STAFF APPROVAL OF PROPOSED CHANGE

CALISTOGA GEOTHERMAL PROJECT UNIT 19

(81-AFC-01C)

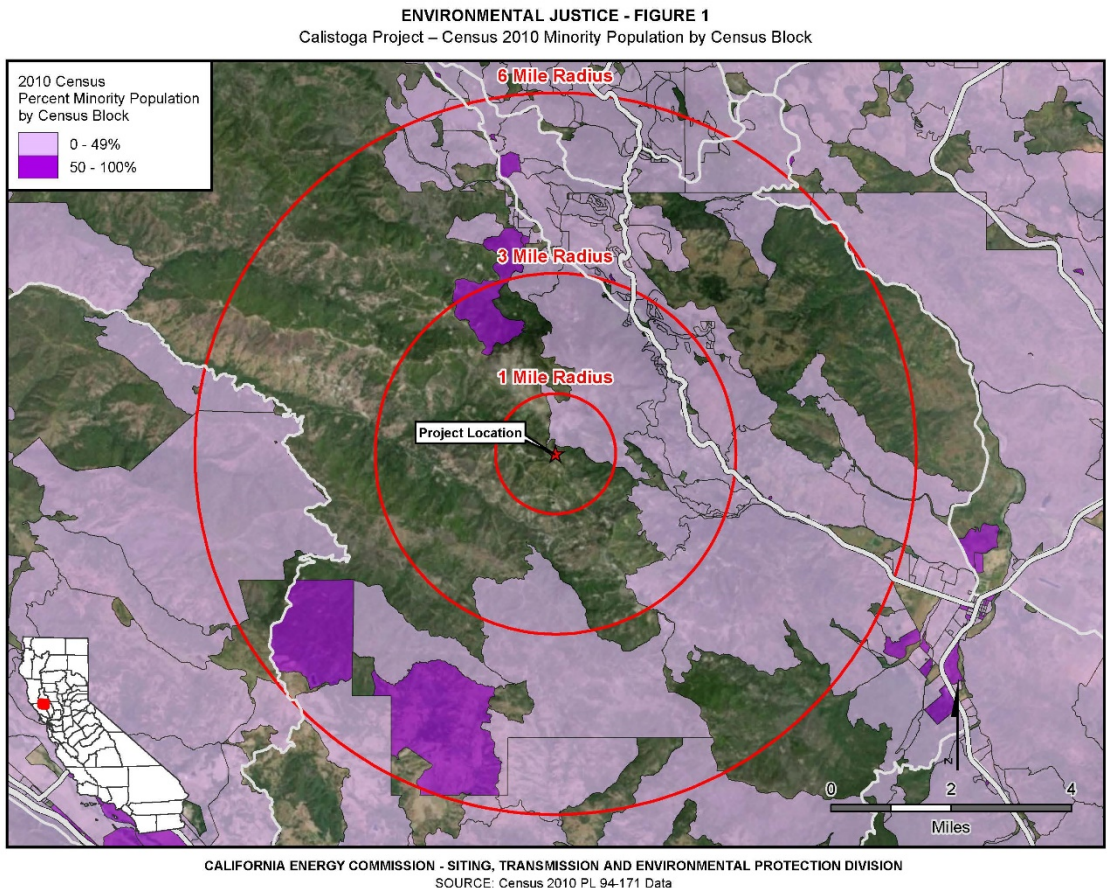
The **Environmental Justice – Figure 1** shows 2010 census blocks in the six-mile radius of the Calistoga Geothermal Power Plant with a minority population greater than or equal to 50 percent. The population in these census blocks represents an environmental justice (EJ) population based on race and ethnicity as defined in the United States Environmental Protection Agency's *Guidance on Considering Environmental Justice During the Development of Regulatory Actions*. Staff conservatively obtains demographic data within a six-mile radius around a project site based on the parameters for dispersion modeling used in staff's air quality analysis. Air quality impacts are generally the type of project impacts that extend the furthest from a project site. Beyond a six-mile radius, air emissions have either settled out of the air column or mixed with surrounding air to the extent the potential impacts are less than significant. The area of potential impacts would not extend this far from the project site for most other technical areas included in staff's EJ analysis.

ENVIRONMENTAL JUSTICE - FIGURE 2
Calistoga Project – Environmental Justice Population Based on Low Income

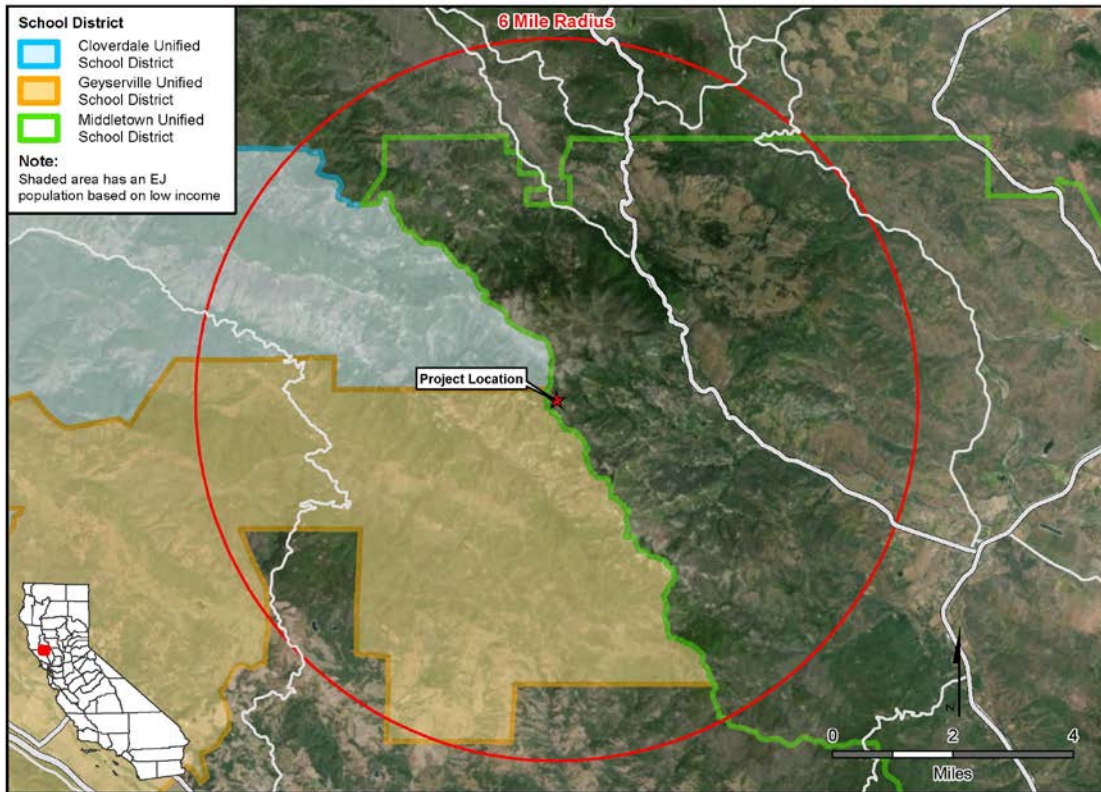
Environmental Justice – Figure 2 shows where the boundaries of the school district are in relation to the six-mile radius around the Calistoga Geothermal Power Plant site.
